ADDENDUM NO. 1

Ishpeming School – Birchview Roof Replacement & A/C Upgrade

Engineer's Job No.: I31-02194

This Addendum, issued this 1st of December 2022 is to clarify, modify and/or change the original bidding document and forms as part of the contract documents. Please provide a cost quote for the the additional items listed below. Acknowledge receipt of this Addendum in the space provided on the Bid Form. Failure to do so may subject the bidder to disqualification.

A1 OVERALL DEMOLITION PLAN
1" = 20'-0"

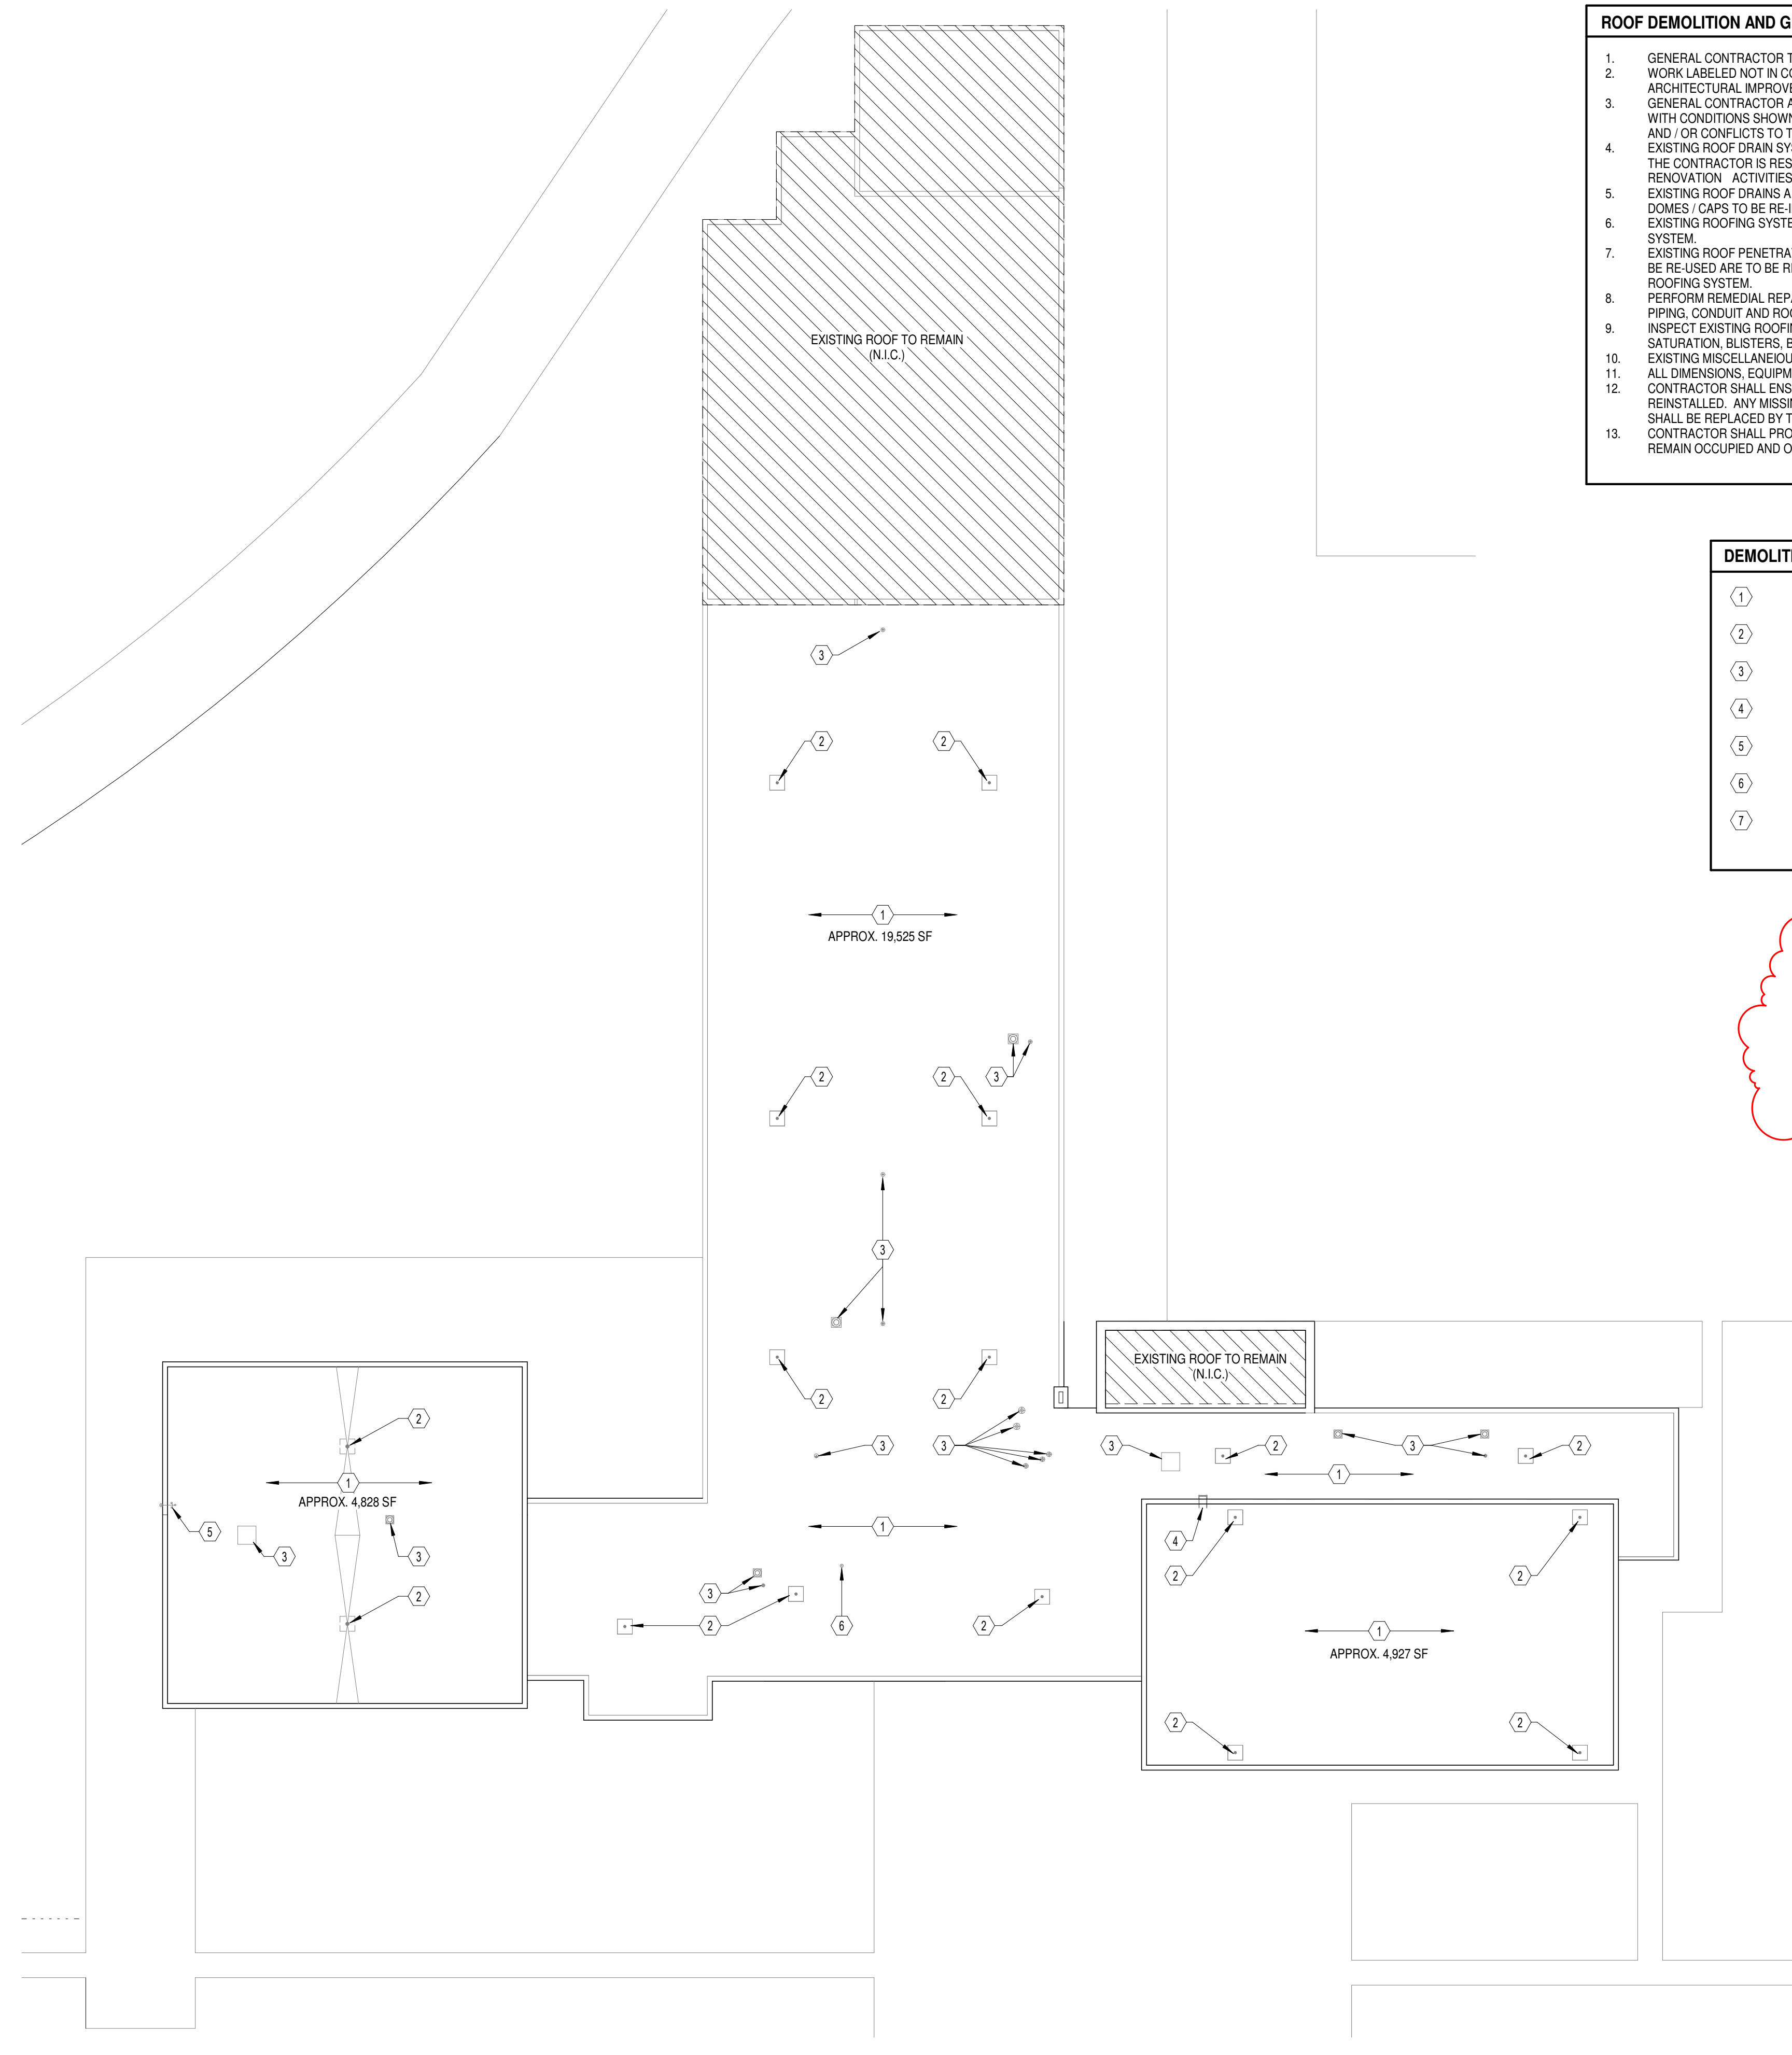
- GENERAL BIDDING NOTES**
- BID ITEM #1:**
- EXISTING EPDM MEMBRANE TO REMAIN.
 - PROVIDE CUTS IN EXISTING MEMBRANE PRIOR TO NEW MEMBRANE INSTALLATION.
 - CLEAN EXISTING SURFACE FOR NEW MEMBRANE INSTALLATION.
- BID ITEM #2:**
- EXISTING EPDM MEMBRANE SHALL BE REMOVED IN ITS ENTIRETY.
 - PREPARE SURFACE FOR NEW LAYER OF 2-INCH RIGID POLYISOCYANURATE INSULATION.
 - PROVIDE ADDITIONAL WOOD BLOCKING AS REQUIRED AROUND PERIMETER TO ALLOW FOR NEW INSULATION INSTALLATION.
 - CLEAN ROOF SURFACE PRIOR TO NEW MEMBRANE INSTALLATION.

A2 OVERALL ROOF PLAN
1" = 20'-0"

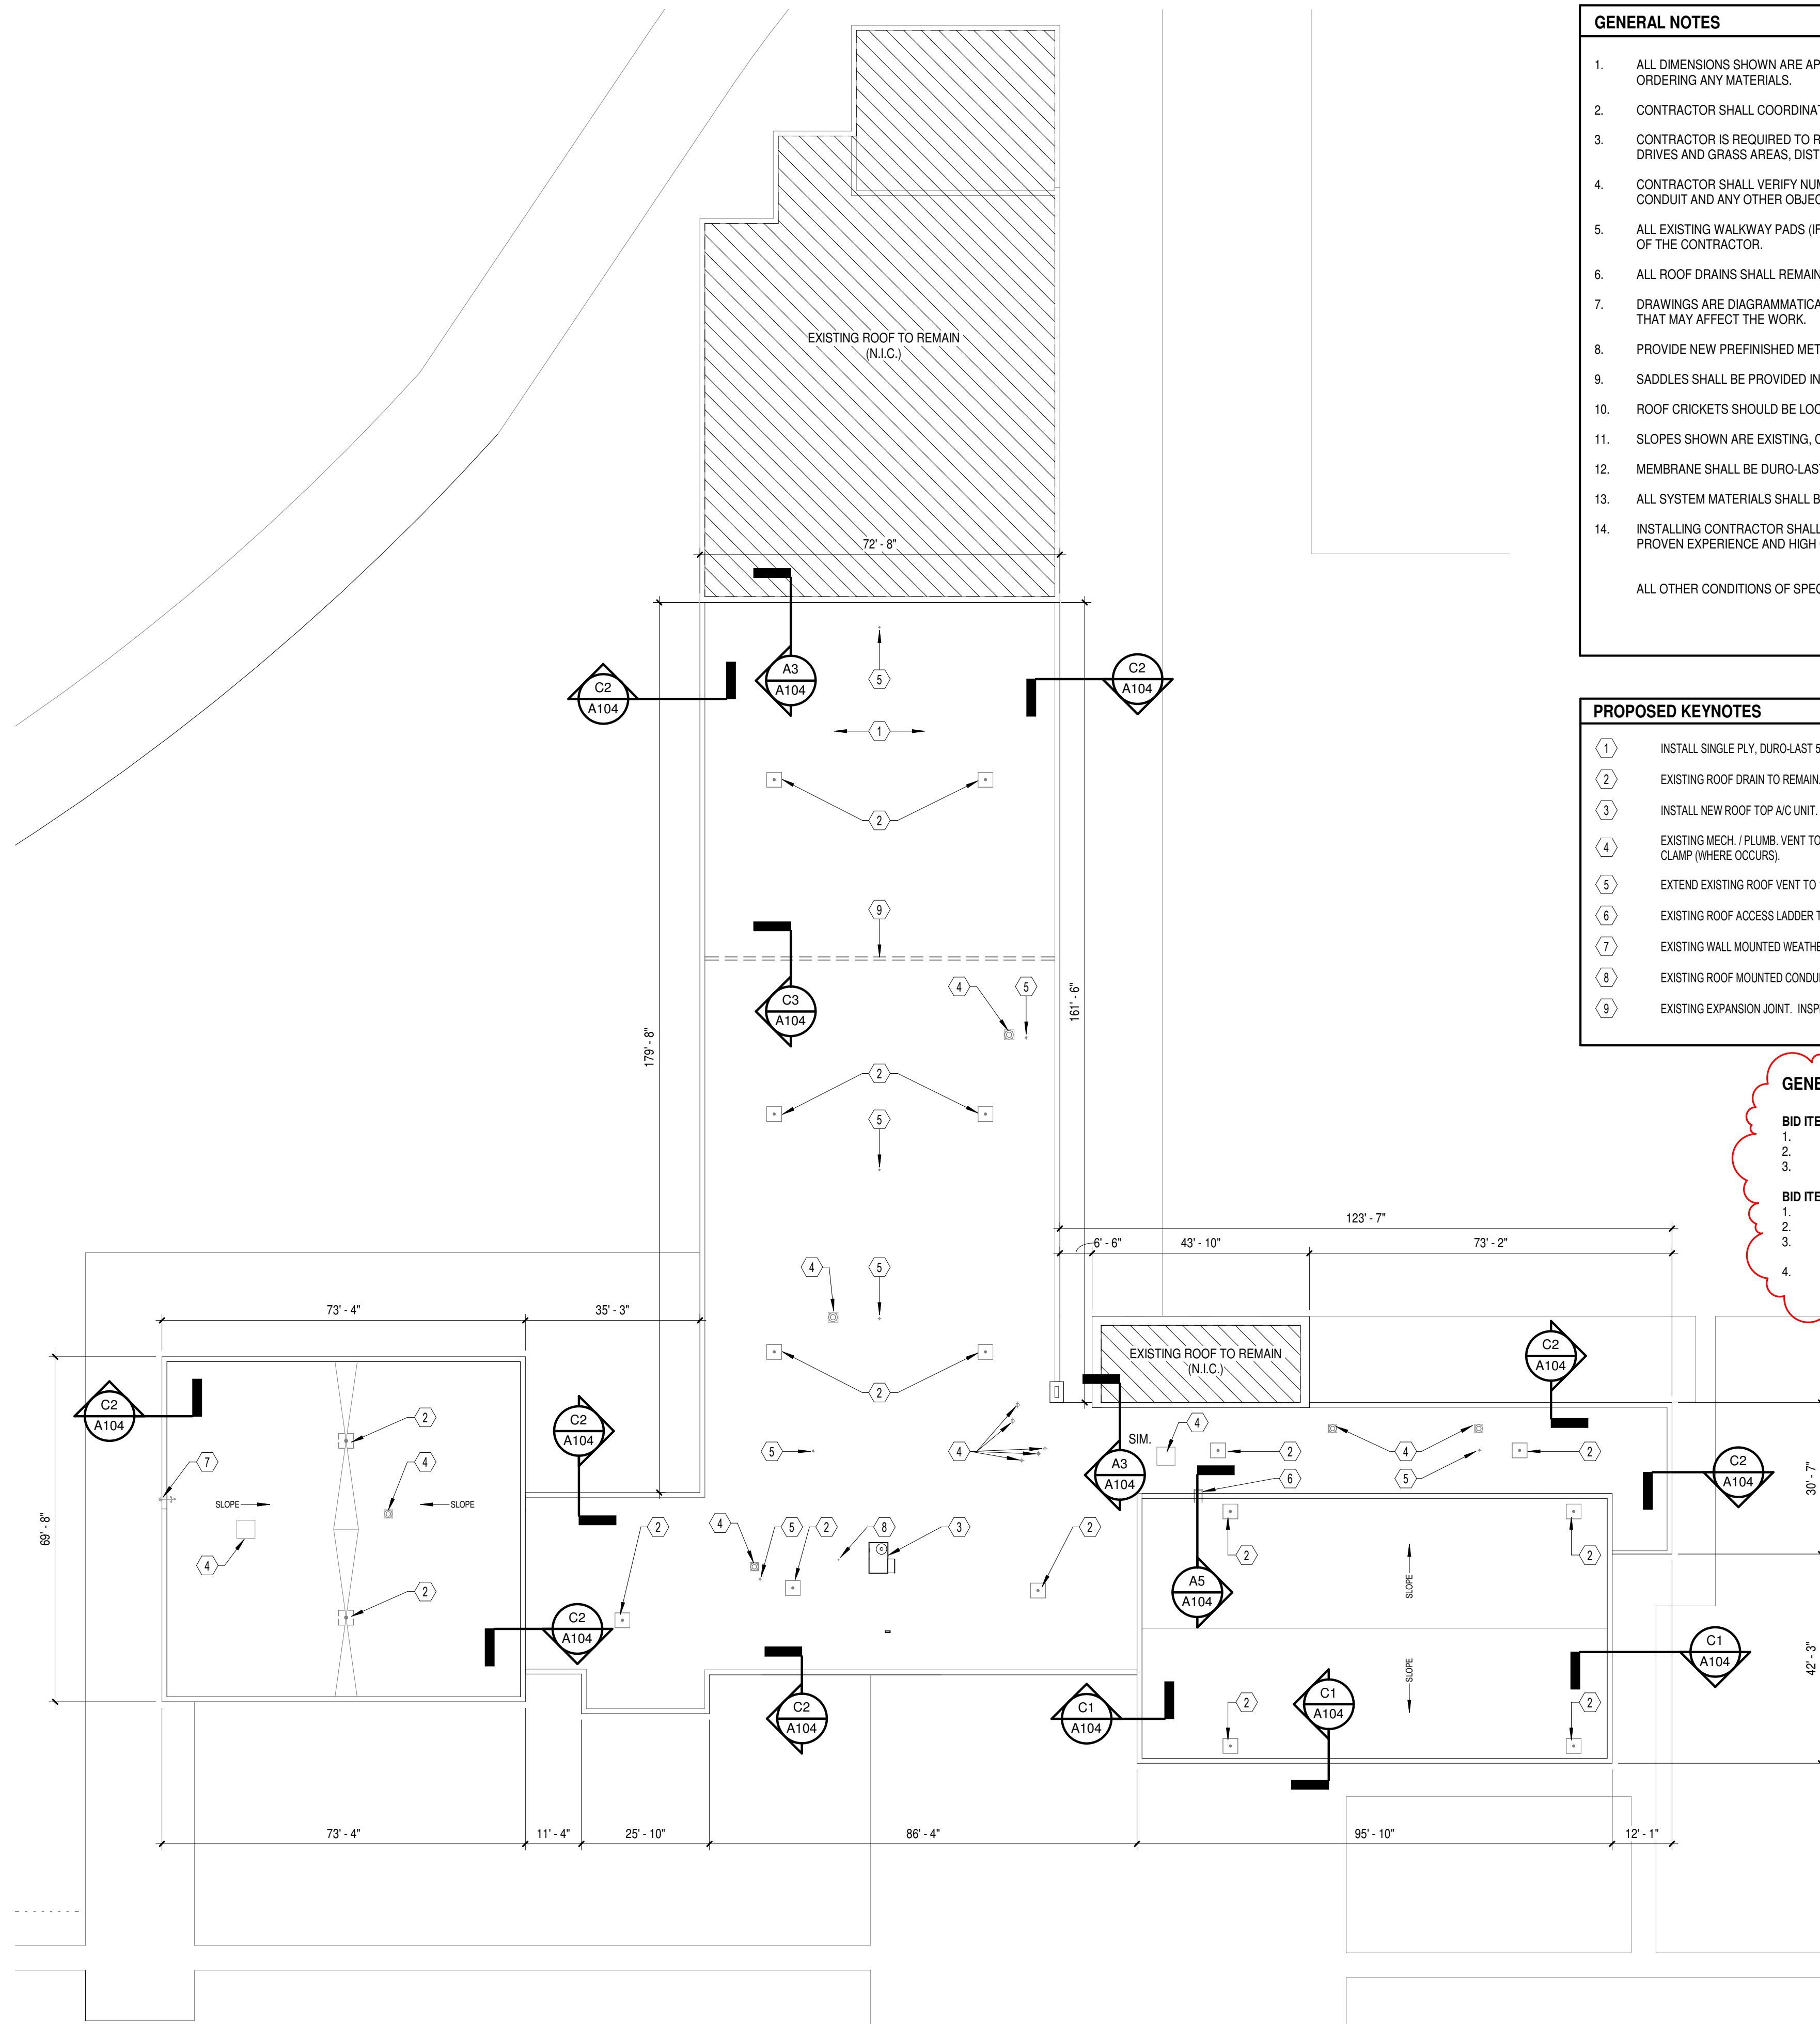
- GENERAL BIDDING NOTES**
- BID ITEM #1:**
- EXISTING EPDM MEMBRANE TO REMAIN.
 - PROVIDE CUTS IN EXISTING MEMBRANE PRIOR TO NEW MEMBRANE INSTALLATION.
 - CLEAN EXISTING SURFACE FOR NEW MEMBRANE INSTALLATION.
- BID ITEM #2:**
- EXISTING EPDM MEMBRANE SHALL BE REMOVED IN ITS ENTIRETY.
 - PREPARE SURFACE FOR NEW LAYER OF 2-INCH RIGID POLYISOCYANURATE INSULATION.
 - PROVIDE ADDITIONAL WOOD BLOCKING AS REQUIRED AROUND PERIMETER TO ALLOW FOR NEW INSULATION INSTALLATION.
 - CLEAN ROOF SURFACE PRIOR TO NEW MEMBRANE INSTALLATION.
